Memorandum

Date: June 16, 2021

Re: Wild Meadows Drainage Assessment – Medina, MN
WSB Project No. 017741-000

Exhibit A - Northerly Area

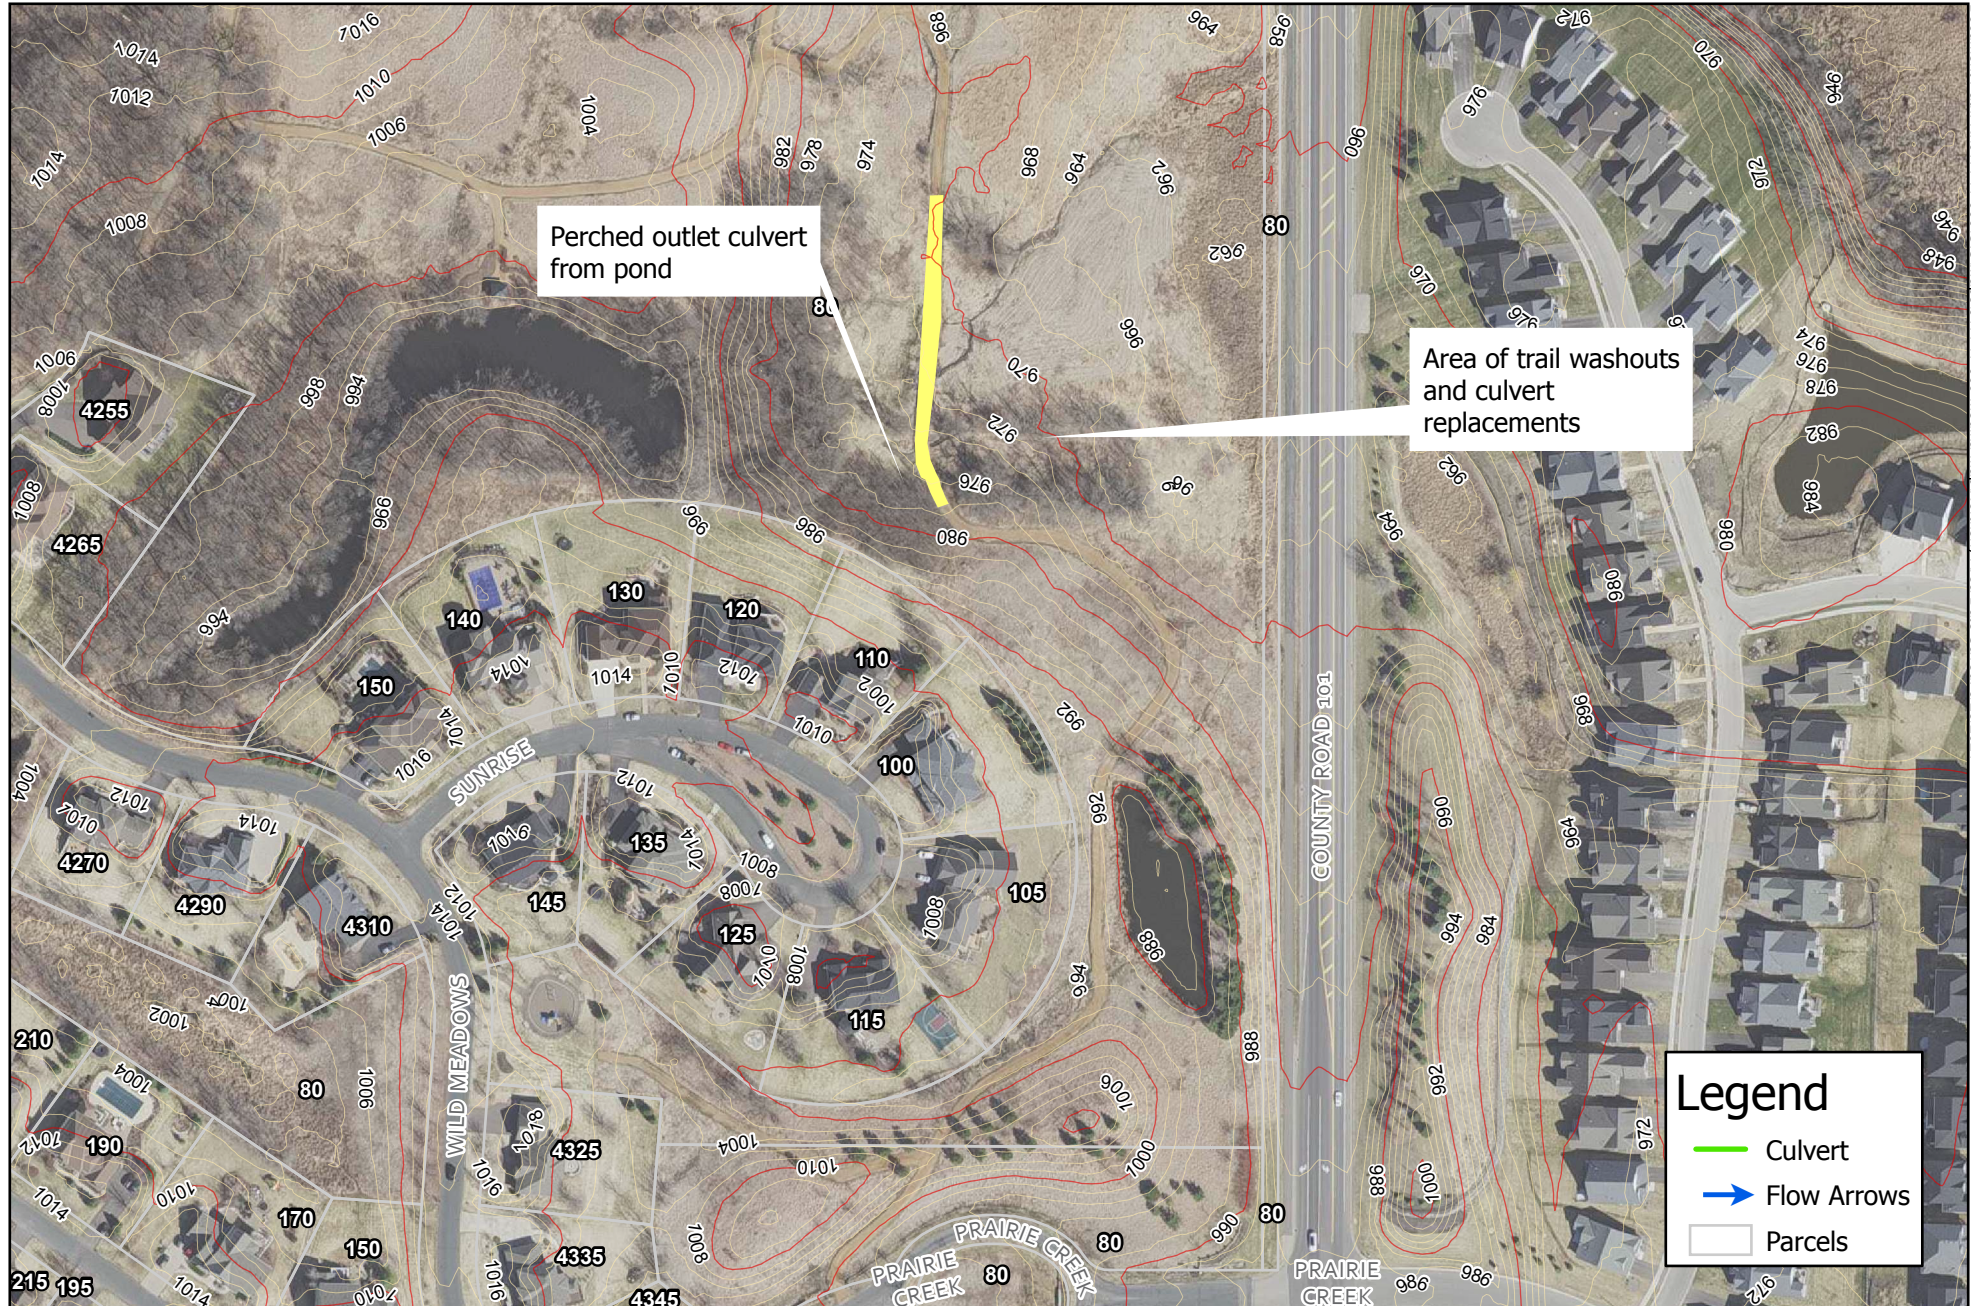
The Northerly Area shown in **Exhibit A** generally consists of the gravel trail located east and north of Sunrise Ct. This trail is comprised of crushed limestone and provides resident access to nature areas north and east of the Wild Meadows development. The original (as-built) condition was a woodchip trail with periodic CMP culverts conveying offsite runoff under the trail. Over the course of several years, and particularly over the last few years, runoff from the west would flow over the trail which lead to multiple culvert washouts and trail erosion.

The primary contributing drainage to the trail area is the upstream outlet/culvert from the pond. This outlet pipe is perched above the downstream grade (appears to stick out of the ground) and currently causing erosion in and around the outfall.

WSB observed and learned of the following modifications/repairs made to the system. The HOA dug small, approximately six-inch wide ditches along the upstream sides of the trail to reduce offsite runoff from flowing over trail and conveyed this runoff to existing culverts. The HOA also replaced and added several new culverts.

These repairs have appeared to reduce the occurrence and amount of runoff flowing onto and over the trail, but increased ditch erosion has also occurred. The added culverts have appeared to reduce occurrence of overtopping, though some of the new and/or existing culverts appear to be undermined; some culverts may also have seepage issues.

Given the elevation difference of approximately 20 feet from the wetland area up to the pond, it is not reasonable to consider the trail work has had any impact on the flow conveyance from the perched pond or nearby yards.

The modifications in this area are not considered to have had a consequential effect on the stormwater treatment train for this area. The changes primarily affected flow conveyance and not water quality.

- Reinstall culverts with the undermining issues utilizing using proper bedding and water-tight seepage prevention measures.
- At the perched outlet pipe location, survey this area and evaluate alternatives for addressing the perched outlet pipe (adding fill, lowering pipe, adding a structure,

- extending the pipe etc.) and install stabilization measures (i.e. rip-rap, permanent turf reinforcing mat, etc.) in and around the outlet area.
- As a long term improvement, consider relocating the trail closer to the outlet pipe area (upstream side of the meadow) to avoid the runoff traveling over the trail. This would require a more significant improvement in design and permitting if pursued; however, it would be a better long term solution.

Exhibit B - Southeasterly Area

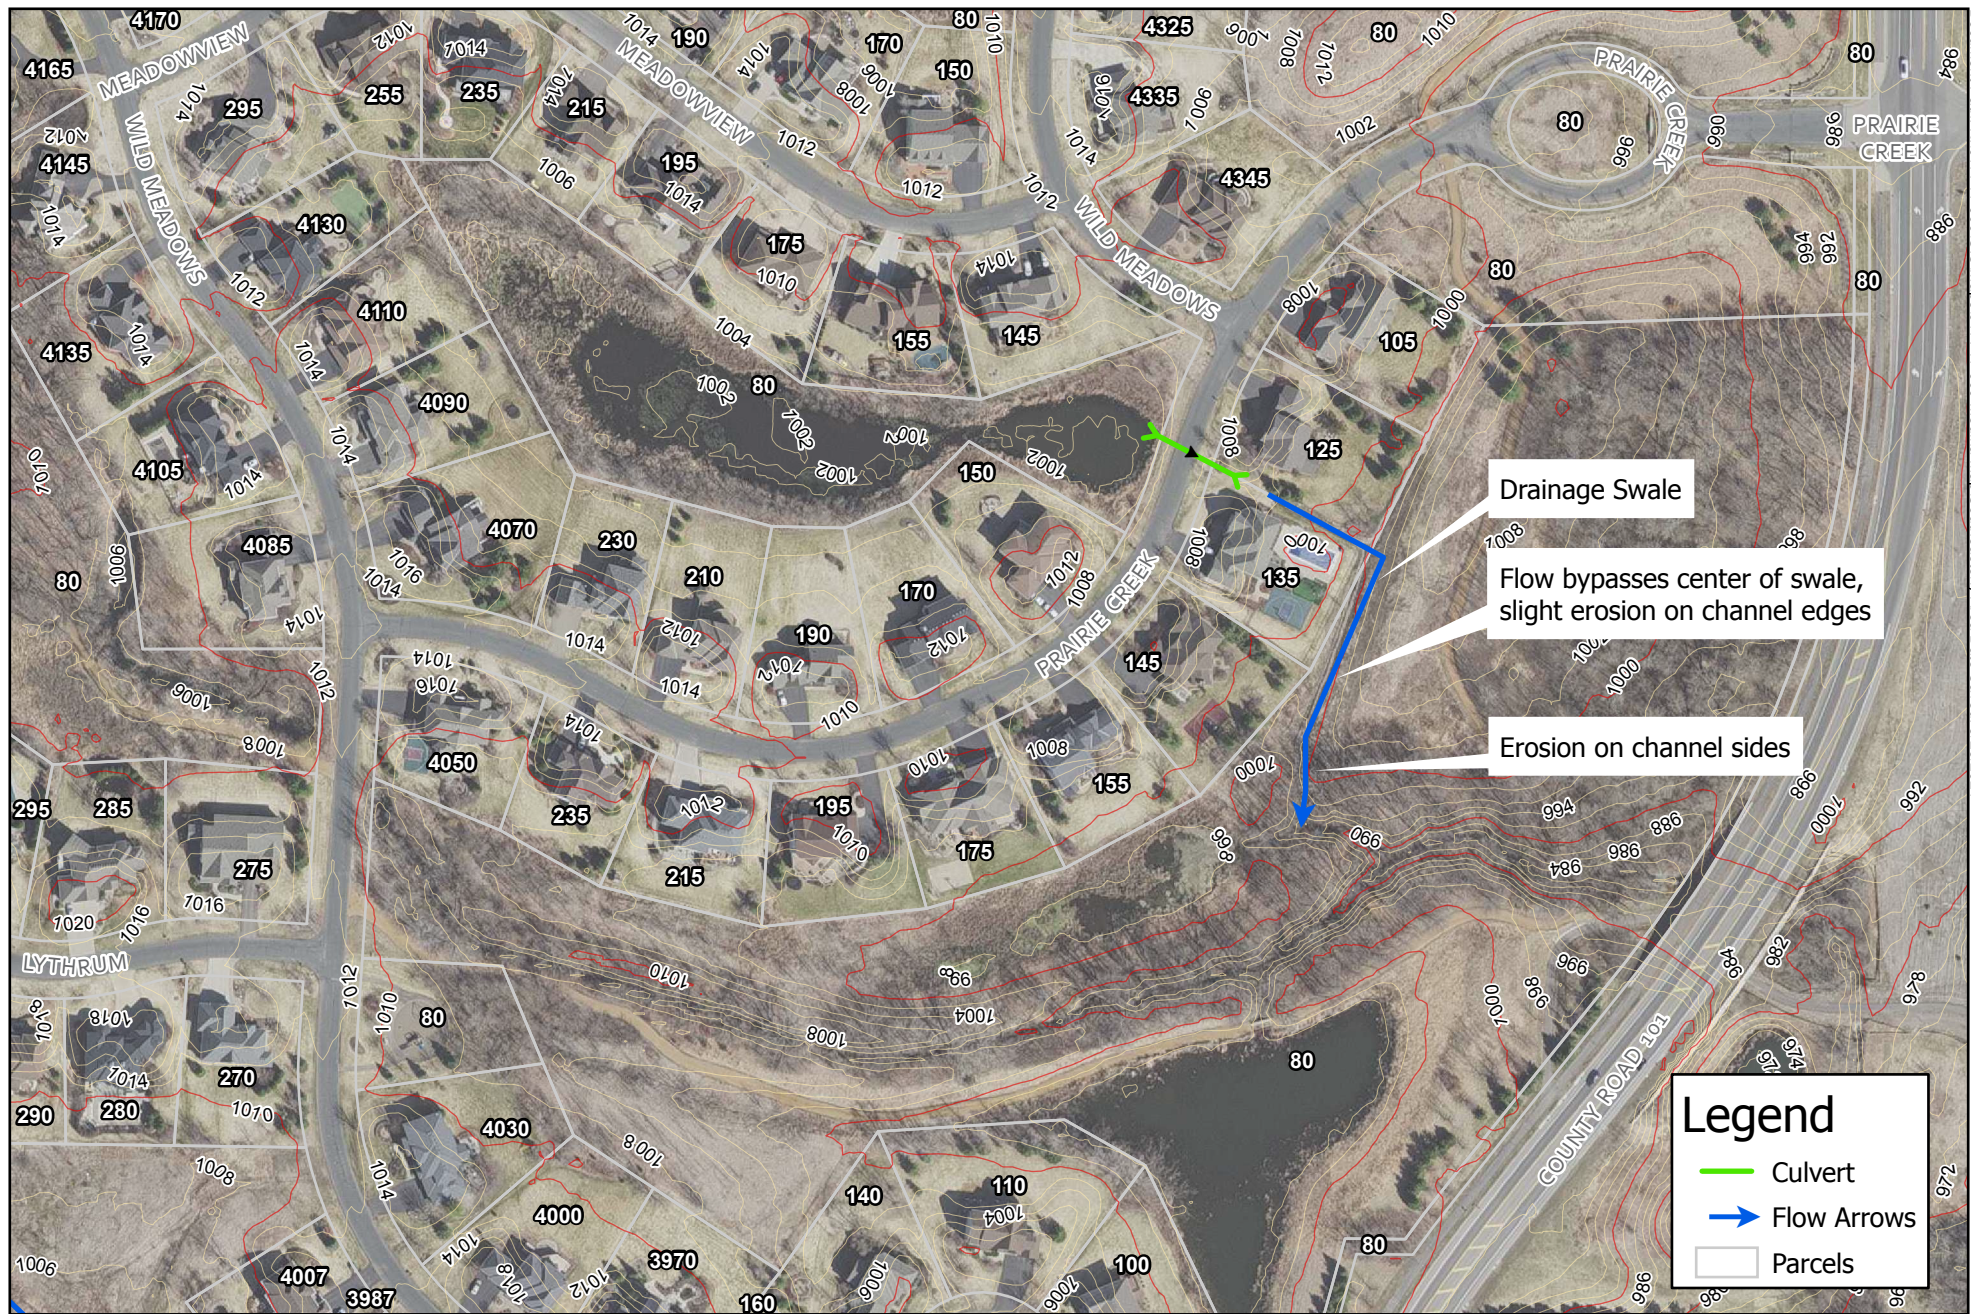
The Southeasterly Area shown in **Exhibit B** generally consists of a drainage swale between 125 and 135 Prairie Creek Rd and flowing behind lots 135 and 145 Prairie Creek Rd. This drainage swale conveys direct runoff from approximately three lots as well as inflow from an upstream pond that receives runoff from approximately 17 lots and associated roads. The original (as-built) condition was a vegetated drainage swale.

Over the last few years, vegetation, including dense cattails, established themselves within the swale causing standing water and restricting flow within the swale. Runoff had encroached into backyards and caused saturated conditions. During previous large storm events, rear yard flooding occurred and extended up to and above the low floor elevation of one home threatening to encroach into the home.

WSB observed and learned of the following modifications/repairs made to the system. To address these issues, the HOA removed vegetation in the swale, widened and regraded, and added 1-2" diameter river rock along swale bottom to reduce vegetation growth and promote flow. Based on HOA knowledge, this repair has reduced the occurrence of standing water and back-ups in the swale.

With respect to water quality treatment, the removal of vegetation slightly reduces the phosphorus removal but given the length and geometry of the swale, it is not expected that the removal of the vegetation will have a significant direct impact on water quality. This conclusion is supported by a very high level assessment of removal efficiencies of swale using the MIDS Calculator. Changing the Manning's roughness value of the swale from vegetation (0.035) to the equivalent of small rocks (~0.02) does not have a sizeable impact on TP or TSS removals. Additionally, most of the flow through this swale comes from the upstream sedimentation pond, which provides the majority of TP and TSS removal.

The changes to the swale did however appear to have resulted in faster velocities in the channel and may have contributed to erosion along downstream side slopes. In some locations the river rock has been bypassed by the flow channel and has further contributed to erosion and sediment loading downstream.

- Repair the downstream portion of the rock swale, where the flow has bypassed the rocks to the side and begun to erode the side slopes. The repair effort should include

regrading to achieve a concave shape with the centerline being at least six inches below the sides.

- Stabilize the eroded side-slopes beyond the end of the rock swale (approximately 30 feet) down the ravine where the slope steepens. Options for protecting the side slopes should consider the lack of sunlight and vegetated understory. Some grading may be required to ensure the flow area is not restricted due to the addition of rip rap or other energy dissipation methods. A few trees may also need to be removed to allow for proper grading of the side slopes.
